SAFETY BULLETIN

No:6

**Interplane
spol.s r.o.**

Type of airplane: Skyboy- all models

Figure 1

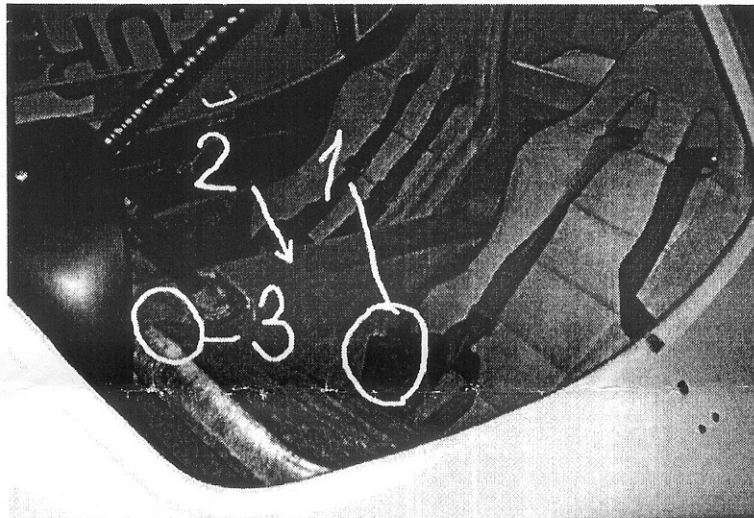
- 1) Remove seats
- 2) Unscrew two safety belts bolts on the sides of central tunel. Fig1, No1
- 3) Remove center tunel Fig 1, No 2
- 4) Find console Fig 2, No 13 in Fig1 Area 3
- 5) Unsrew one bolt on front console Fig 2, No 130 Step 1in Fig3
- 6) Drill asmall hole in the head of the bolt. Fig 3, Step 2
- 7) Screw the bolt beck in. Use Loctite. Fig 3, Step 3
- 8) Repete the same procedure on second bolt. Fig 3, Steps 4-6
- 9) Wire the bolts together. Fig 3, Step 7
- 10) Check to make sure bolts are tight
- 11) Reinstall center tunnel
- 12) Reattach safety belts bolts
